# Regional Review Finding Development of Regional Impact

**RE:** Development of Regional Impact (DRI) Review

**Name of Proposal:** 1611 Ellsworth DRI 4506  
**Submitting Local Government:** City of Atlanta  
**Date Opened:** October 3, 2025      **Date Closed:** October 17, 2025

GSWCC NO. (LEVEL II) 0000076497  
DRAWN BY BCD  
DESIGNED BY MTK  
REVIEWED BY JRH  
DATE 9/16/2025  
PROJECT NO. 013686007  
TITLE  
**DRI #4506 SITE PLAN**  
SHEET NUMBER  
**C0.20**

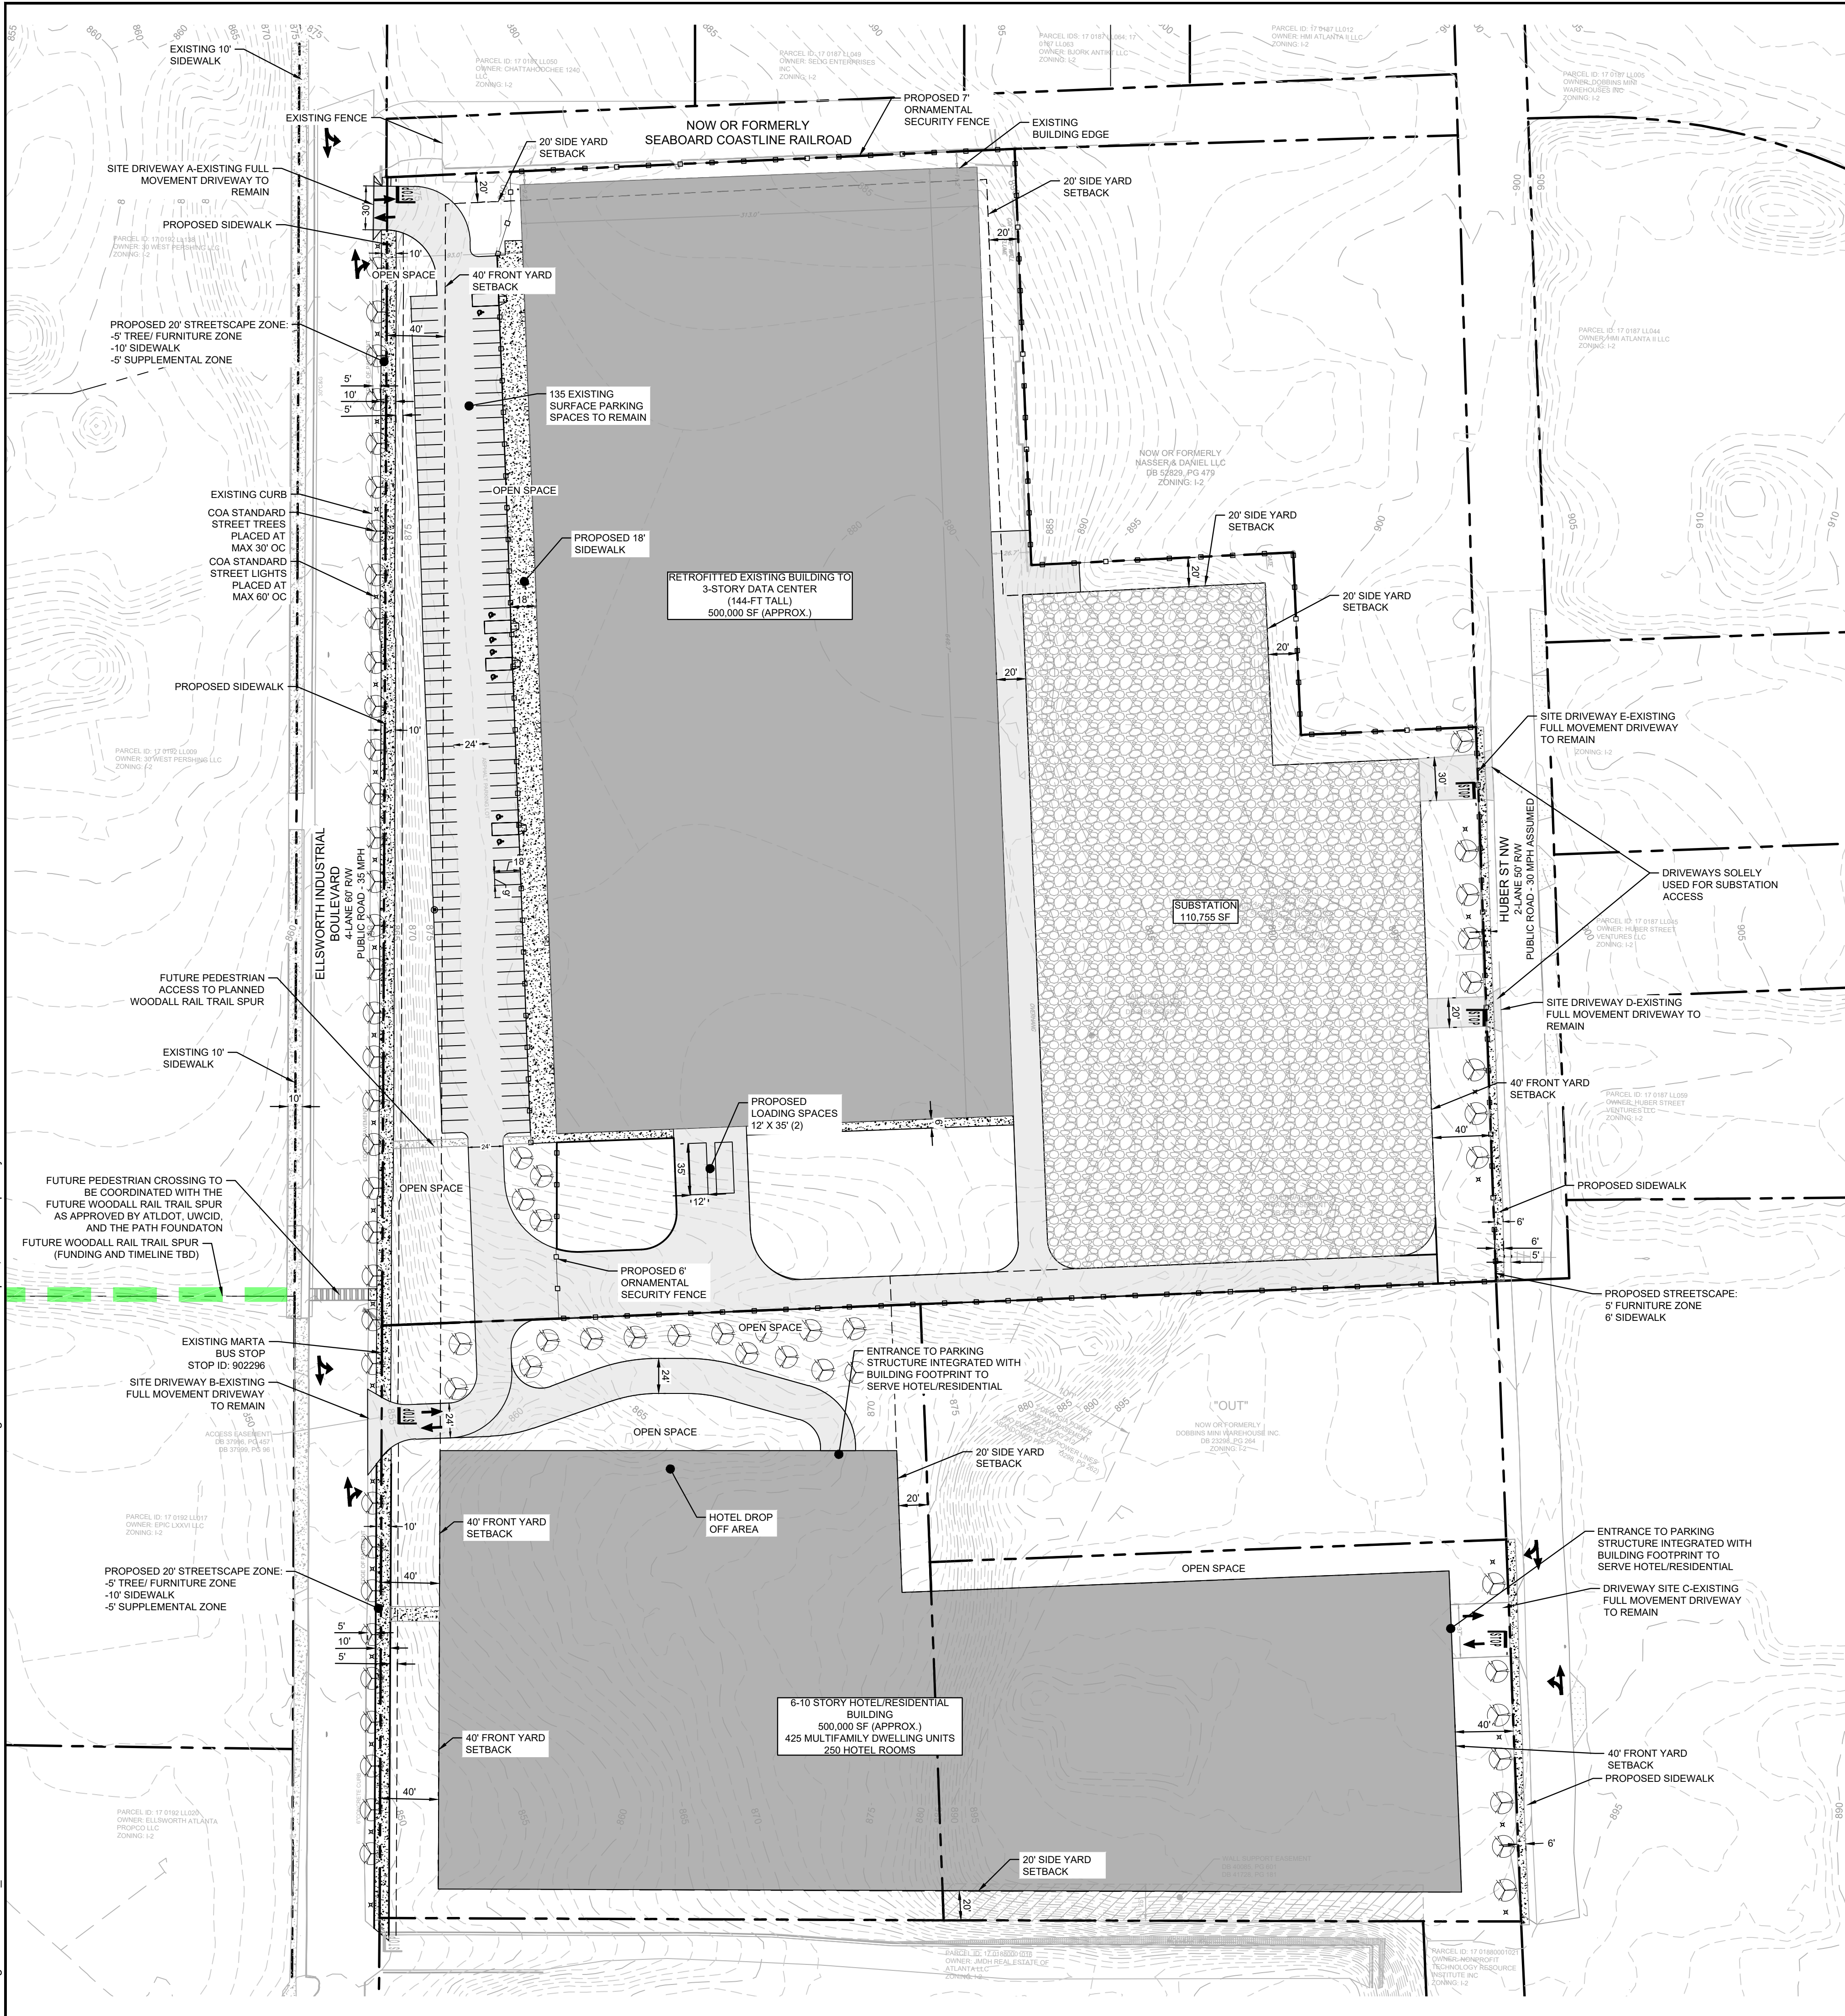
The constructed development should provide an interconnected, functional, clearly marked and comfortable pedestrian experience on all driveways, paths, entrances, and parking areas. To the maximum extent possible, new driveways and intersection corners where pedestrians will cross should be constructed with minimal curb radii to reduce speeds of turning vehicles and decrease crossing distances for pedestrians.

Walking Access\* *Trails are all walkable and bikeable along Ellsworth Industrial Blvd path. Path is only on one side of road, so mid-block crossings or improved crossings would help improve access and safety.*

GSWCC NO. (LEVEL II)	0000076497
DRAWN BY	BCD
DESIGNED BY	MTK
REVIEWED BY	JRH
DATE	9/16/2025
PROJECT NO.	013686007
TITLE	DRI #4506 SITE PLAN-AERIAL
SHEET NUMBER	C0.21

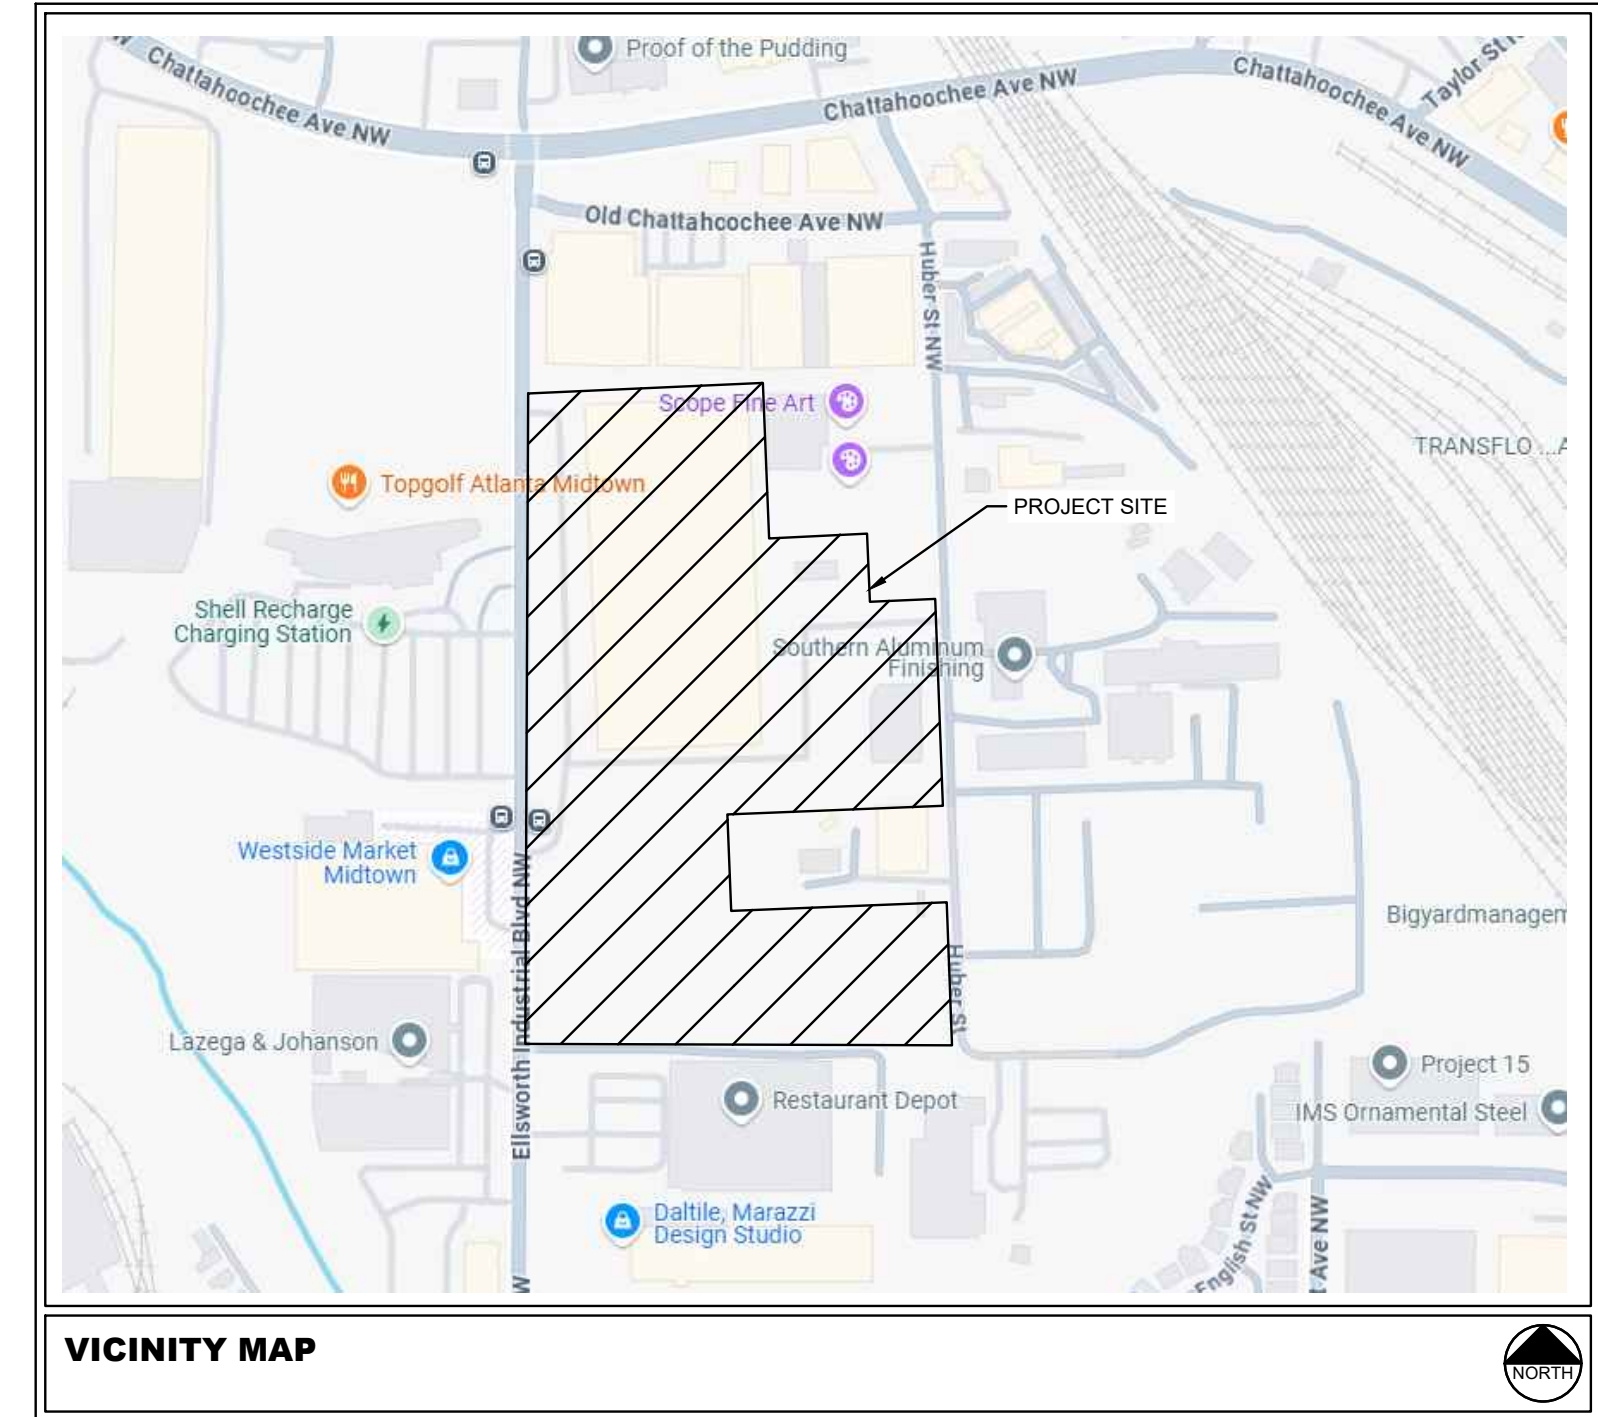
*The proposed crosswalk across Ellsworth is critical to providing a minimal level of pedestrian connectivity to the site given that there is no sidewalk along the east side of Ellsworth from the project south to the now open Beltline entrance at Elaine Street.*

*The final project design should be carefully coordinated with the final design of the immediately adjacent Huber West Midtown DRI 4363 project to the east which does not have pedestrian access to Ellsworth and the two MARTA stops located there or to the Beltline to the south. Ideally this project would provide some kind of pedestrian passage on the north side of the building connecting Ellsworth to Huber Street which would greatly facilitate multi-modal access to both projects.*

*The southern part of the site where the hotel/residential is proposed is heavily wooded and provides significant cooling and stormwater benefits. Every effort should be made to retain as many of the trees in this area as possible and to replant as many trees as possible elsewhere on the site.*

*Pedestrians are able to move between destinations within the site but a sidewalk within the site between Ellsworth and Huber should be considered. Bike improvements within the site should be considered as well.*
